AMENDMENT NO. 1

WISHART PLACE

AGREED STRUCTURE PLAN NO.1

**AMENDMENT NO. 1 TO THE
WISHART PLACE AGREED STRUCTURE PLAN NO. 1**

FIGURE 2 - DESIGN CHANGE
 LOT 371 HORSLEY ROAD
 DENMARK

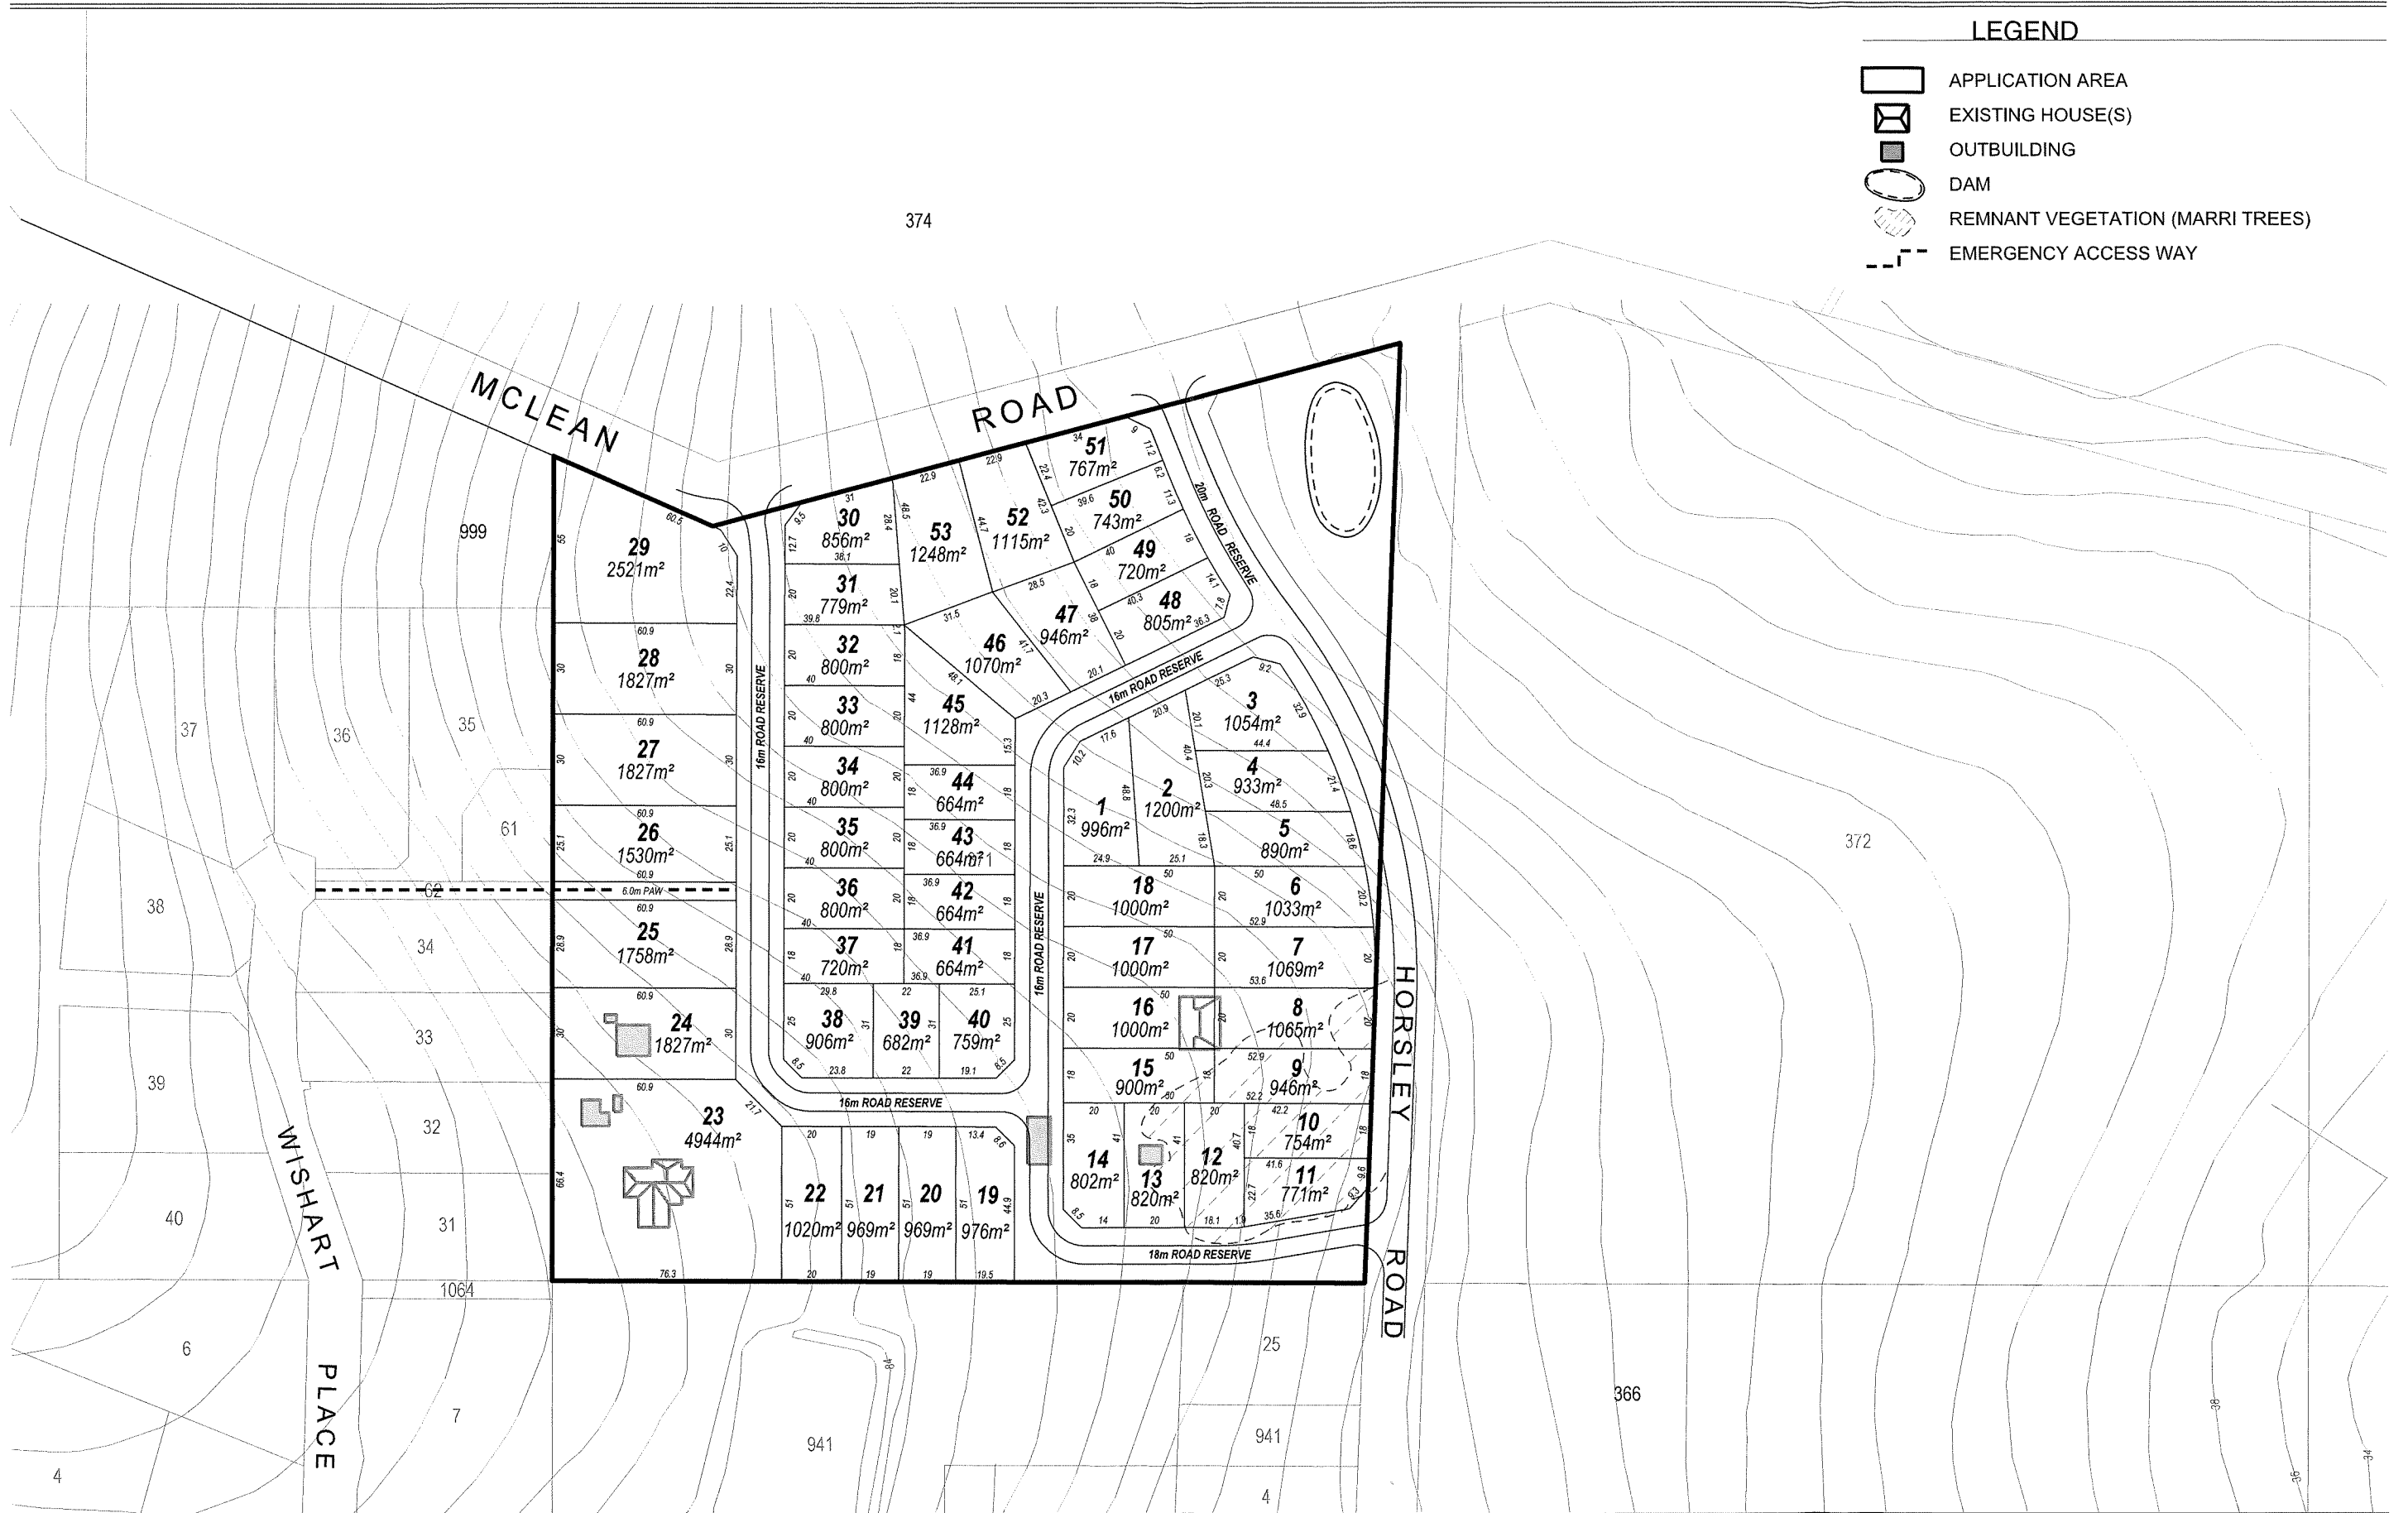
As identified in **Figure 2**, the design change relocates the southern, east- west aligned access way to the southern boundary of the site. The design change will impact the proposed lots in the south eastern corner of the site only (i.e. there will be no change to other lots in the Structure Plan).

The relocated southern access road traverses in a northerly direction at the boundary of proposed Lot 19 as referenced in **Figure 2**. Given the lot sizes, Lots 19-22 can be developed backing onto the Water Corporation's treatment infrastructure without buffer or BAL implications (refer BMP **Appendix B** confirming BAL contouring).

The design change requires less remnant vegetation to be removed in the future lots as opposed to the current design where the majority of vegetation is located in the road reserve and will require removal. In addition to this, relocating the subject east-west aligned access road enables a greater number of lots to be east west orientated as opposed to the current design, which has predominantly north south orientated lots in this location. This is of benefit as it enables the future lots to have a greater northern exposure and hence future dwellings can be designed for greater passive solar gain.

The intersection of the relocated access road from the site to Horsley Road makes allowance for safe vehicle access with a suitable truncation. The identified truncation area (refer the south eastern location in **Figure 2**) will be ceded to the Crown free of cost for the purpose of road reserve at the time of subdivision.

FIGURE 3 - CURRENT SUBDIVISION GUIDE PLAN
 LOT 371 HORSLEY ROAD
 DENMARK

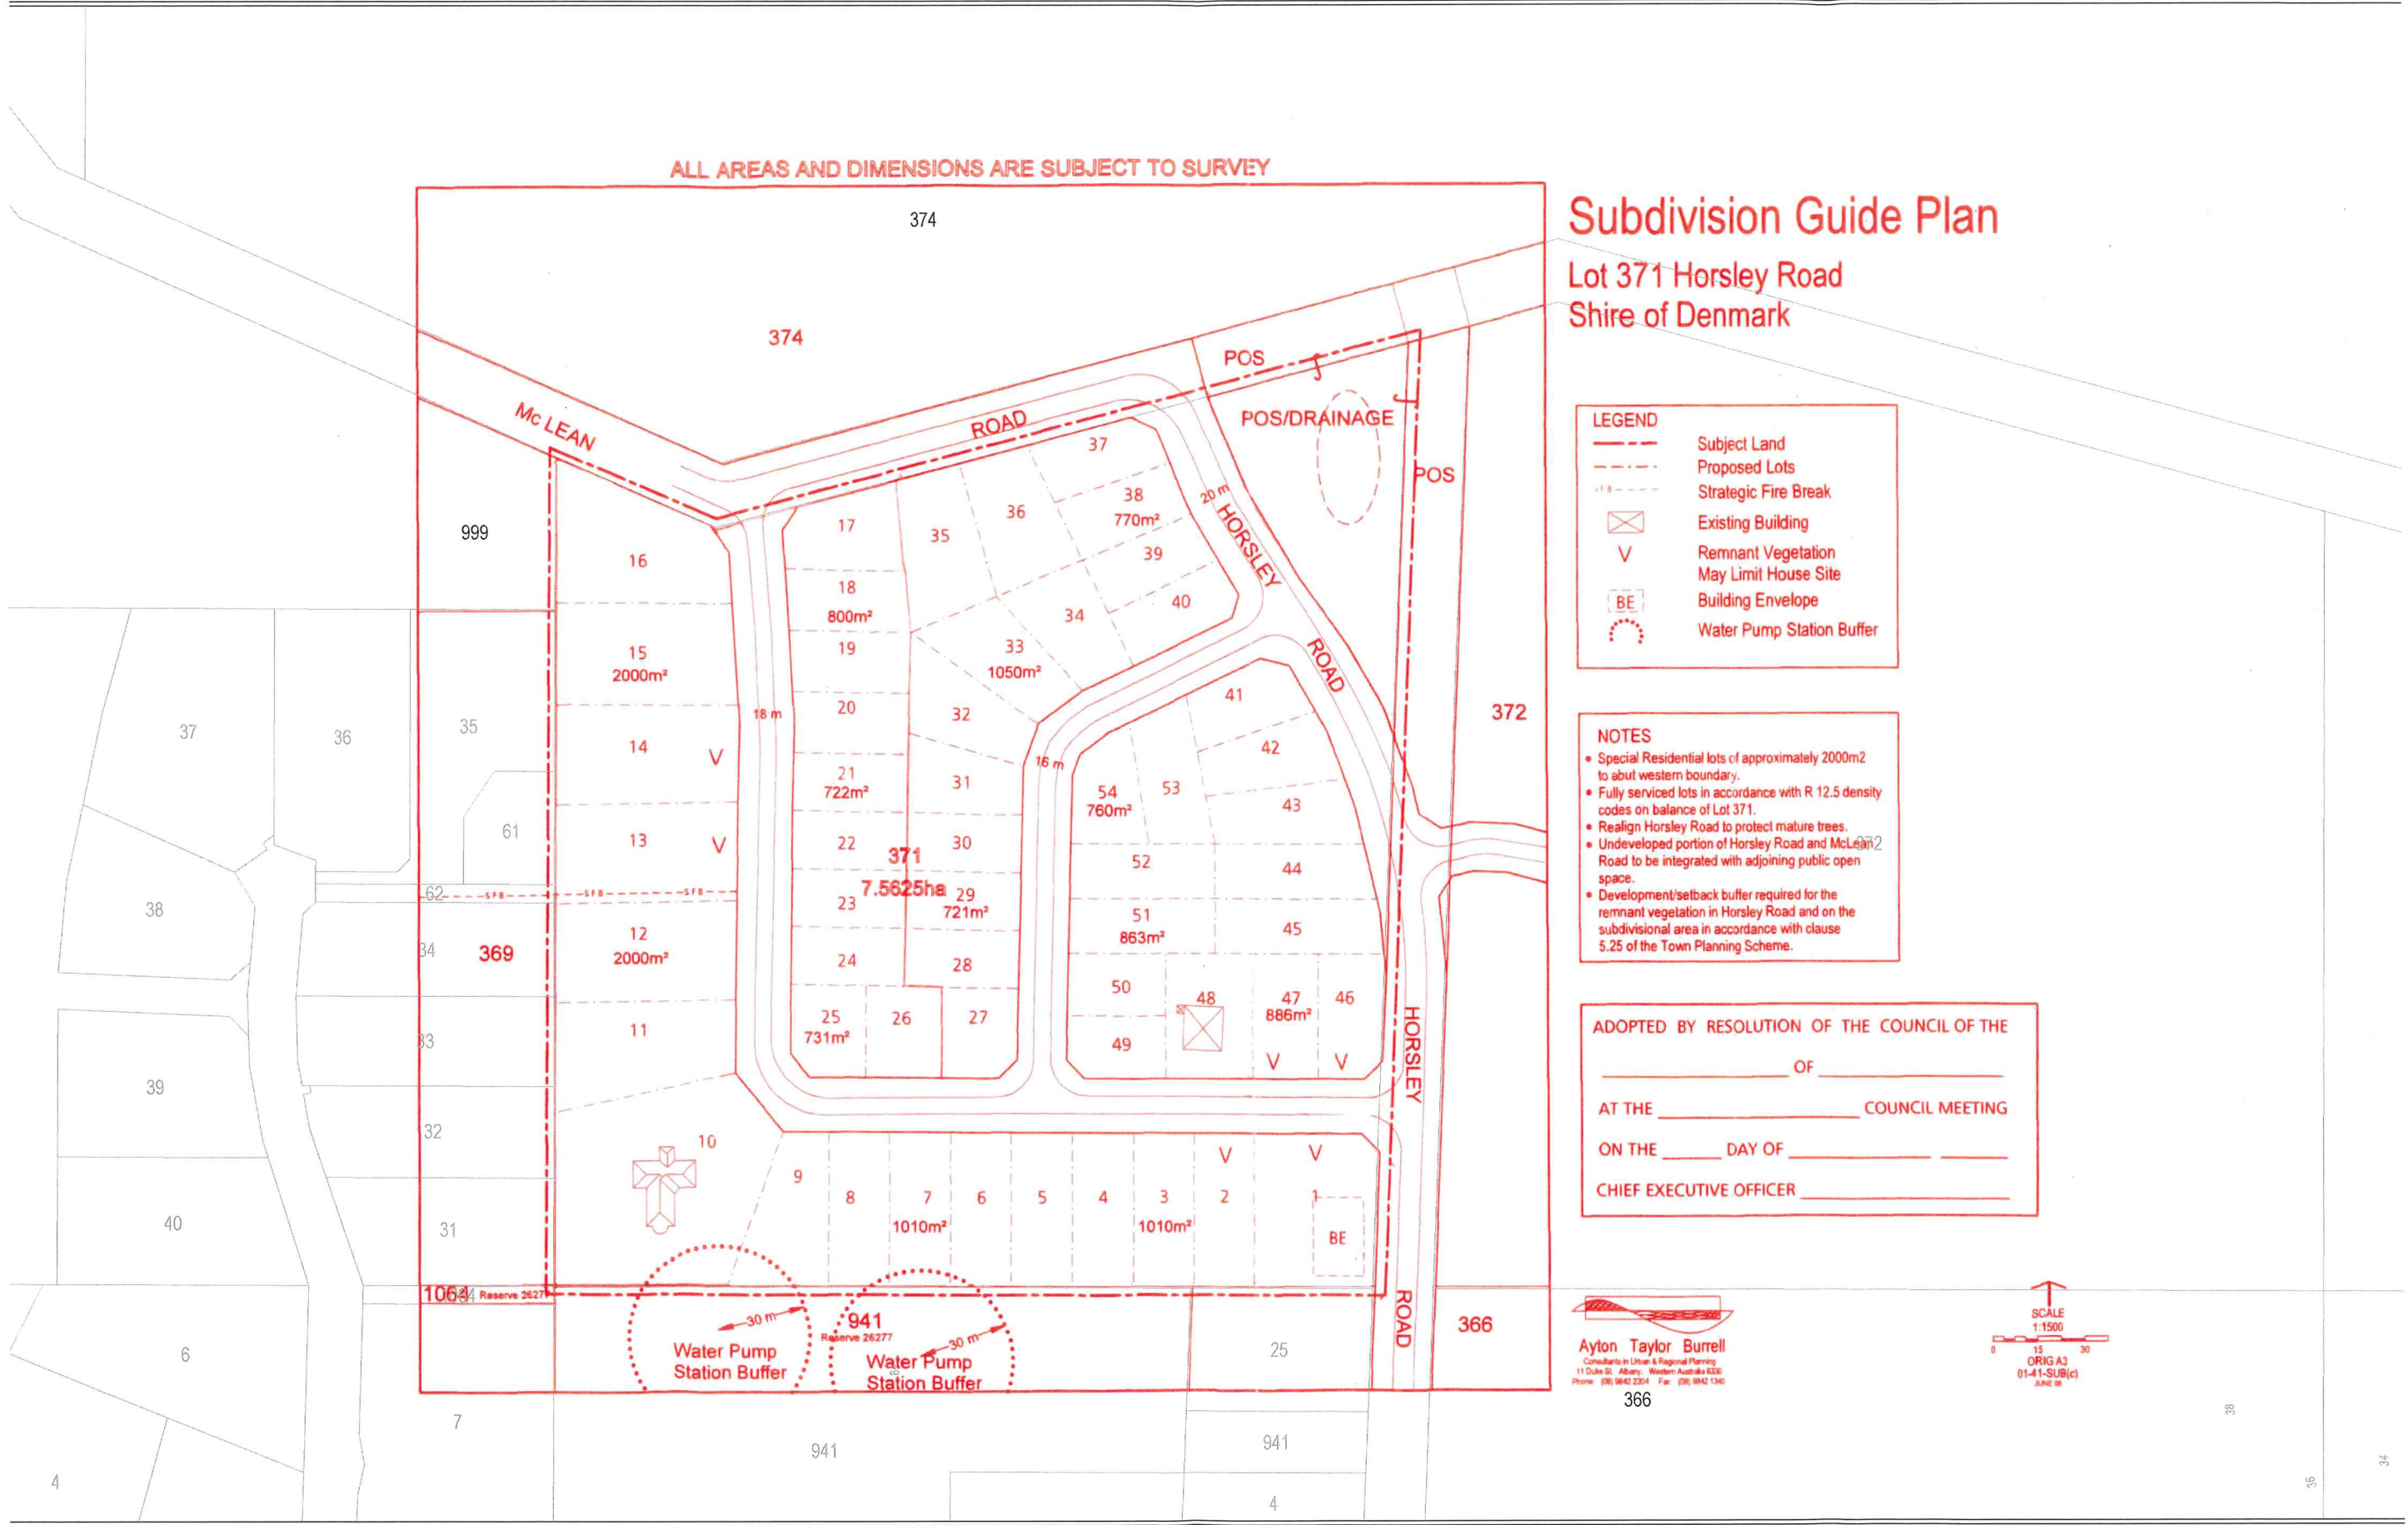
The purpose of the Structure Plan Amendment is to facilitate a design change over the site. In accordance with the current design (refer attached **Figure 3**), the southern east-west aligned access way connecting Horsley Road currently traverses a route comprising significant remnant vegetation, which at the time of road construction will require removal.
